NCC2022 SECTION J PART J4 PERFORMANCE-BASED DESIGN BRIEF (PBDB)

OPAL ST IVES BOTANICA

Project Number	250251
Project Name	Opal St Ives Botanica
Description	NCC2022 Section J Part J4 Performance-Based Design Brief (PBDB)
Key Contact	Onofrio Marzulli

DOCUMENT No.: 250251
 DOCUMENT TITLE: Opal St Ives Botanica - Building Fabric Requirement
 DOCUMENT REV: Rev A
 DOCUMENT BY: TST DATE: 14/11/2025

Drawing Title	ROOF	
Scale	As indicated	
Drawing Created (date)	11/28/23	
Drawing Created (by)	Author	
Plotted and checked by	Designer	
Verified	Checker	
Approved	Approver	
Project No	Drawing No	Issue

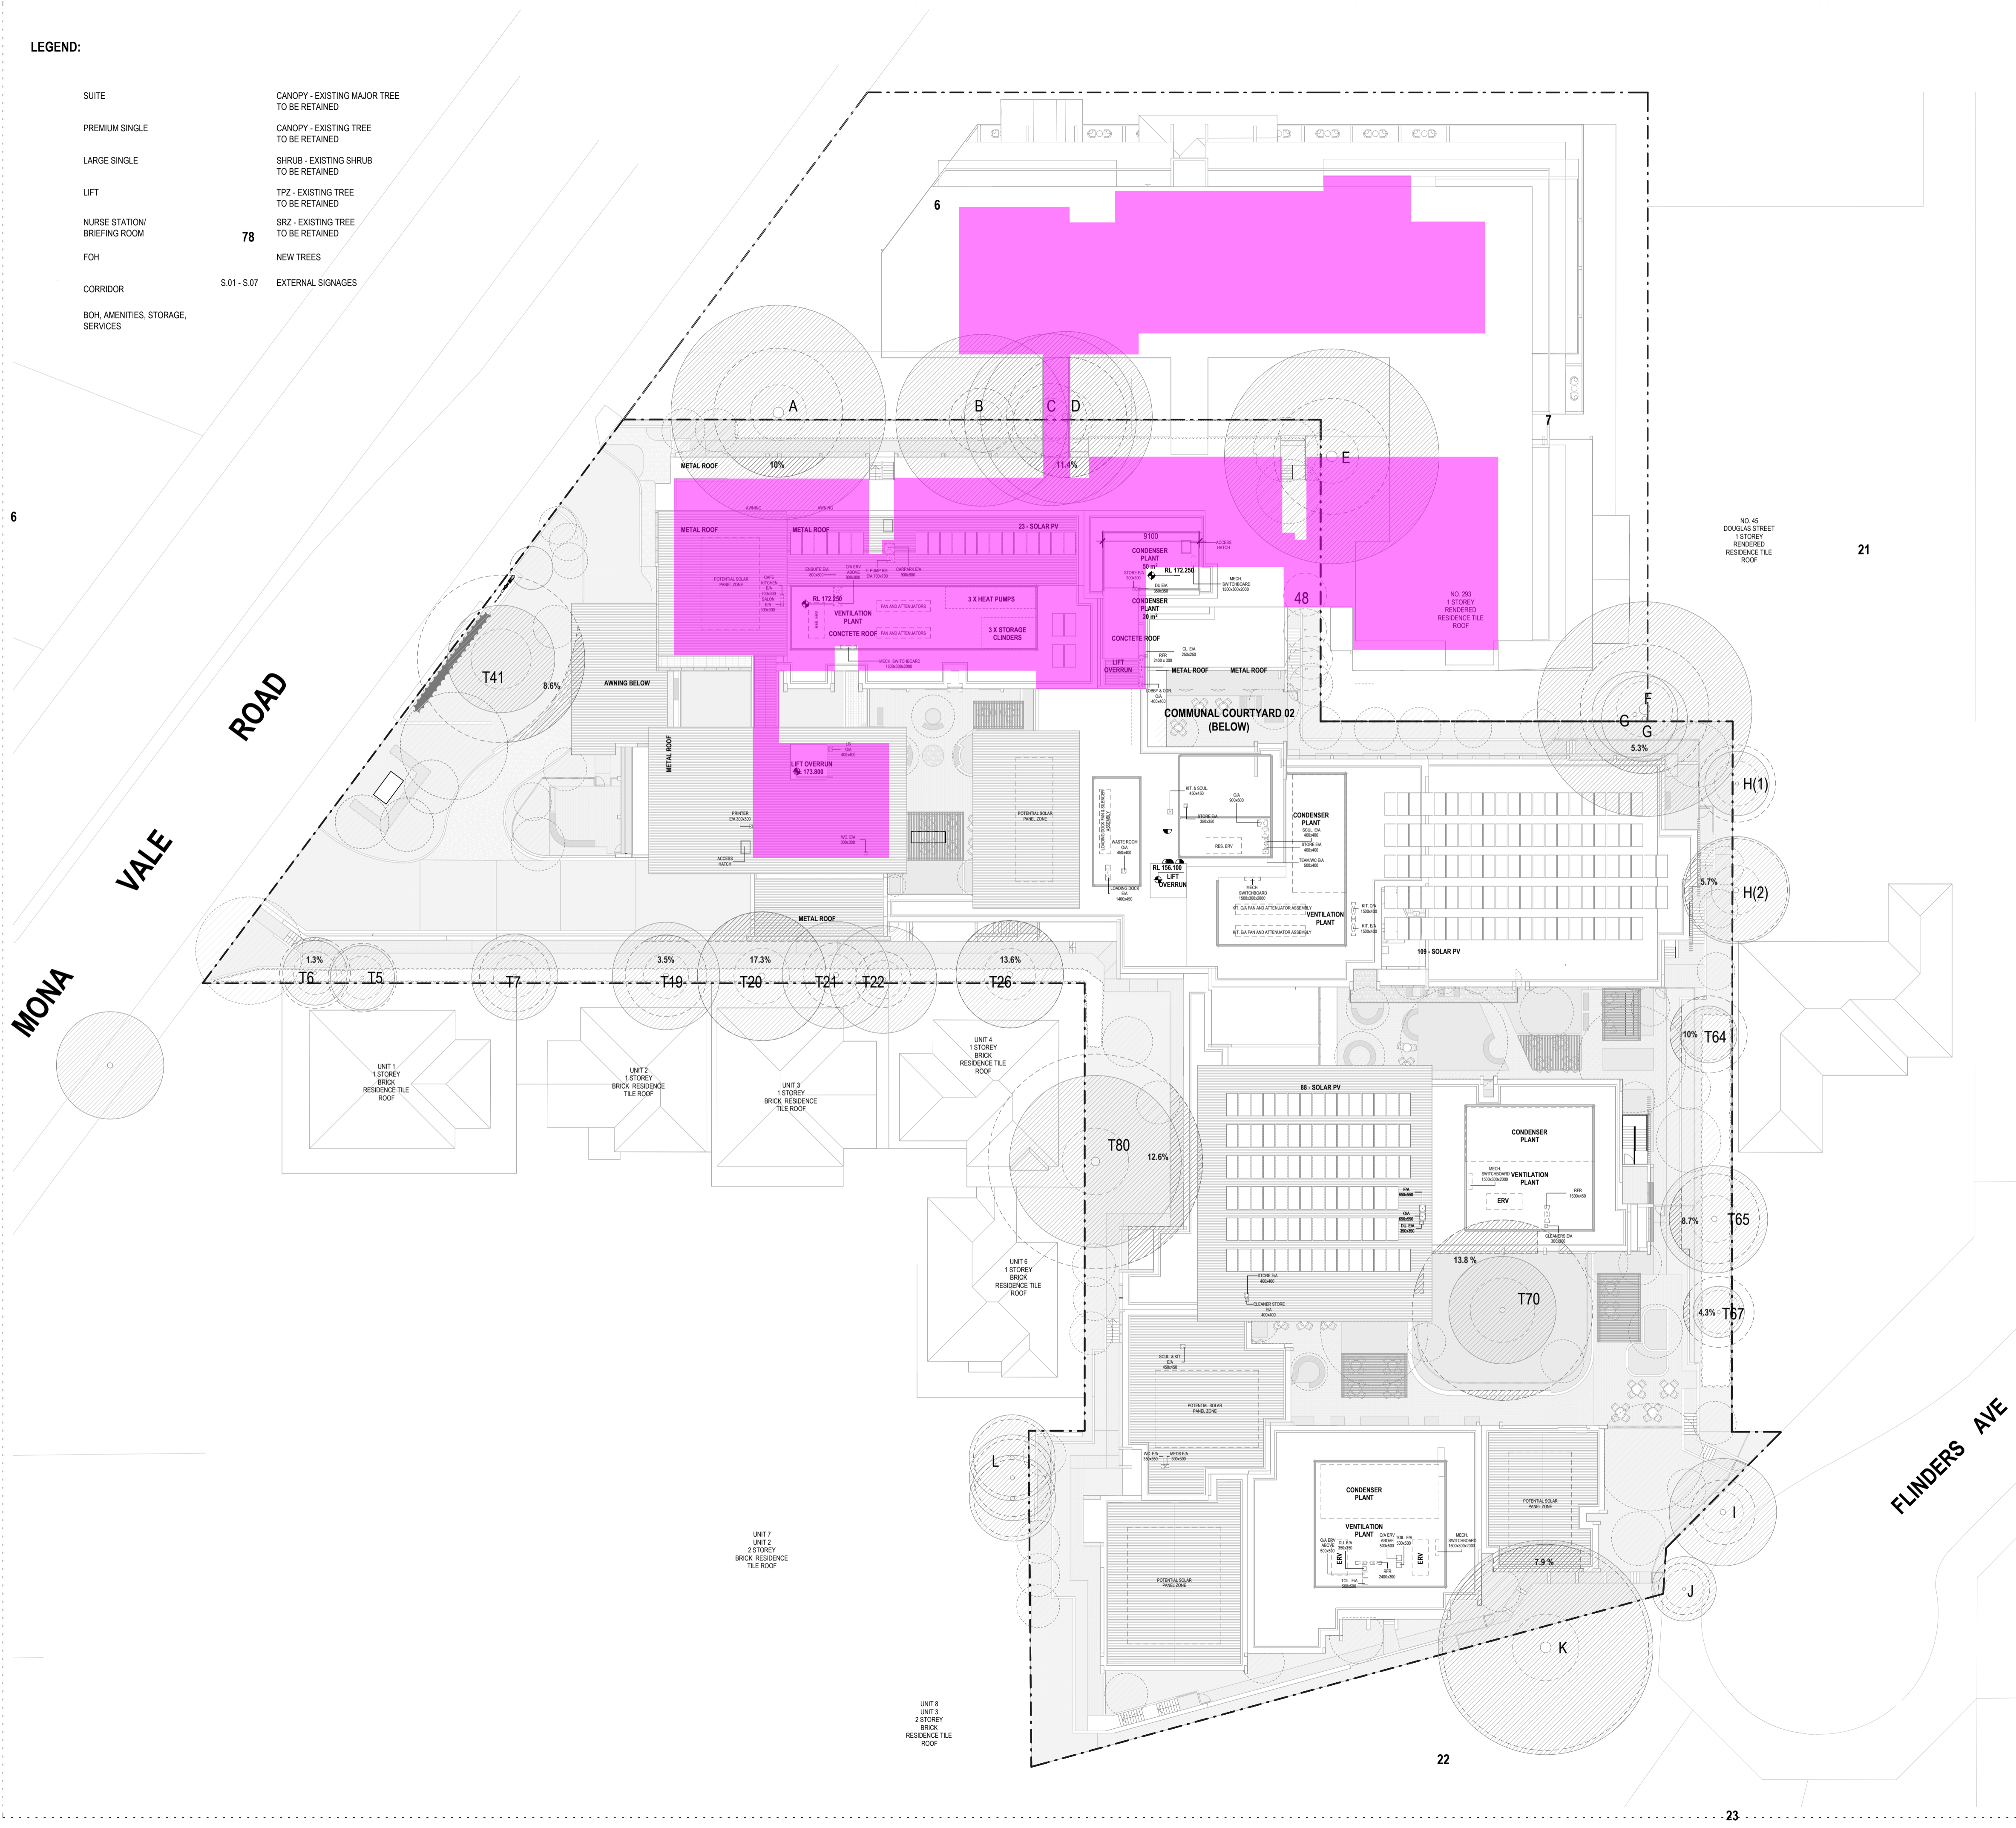
JHA
MARKUP / SKETCH

- ROOF/CEILING ENVELOPE :- TOTAL R4.1 (DOWNWARD, SOLAR ABSOPTANCE NO MORE THAN 0.40)
- ENVELOPE FLOORS (SUSPENDED):- TOTAL R2.2 (DOWNWARD)
- ENVELOPE FLOORS (SLAB-ON-GROUND):- TOTAL R2.2 (DOWNWARD)*
- ENVELOPE WALLS :- TOTAL R1.6

Note: The above construction are only to be applied to the non-glazed portions of the envelope; glazing must be installed as per the architectural layouts with its thermal performances pursuant to the respective glazing specifications stated in the Section J report (Total Systems U-Value, and Total Systems SHGC value).
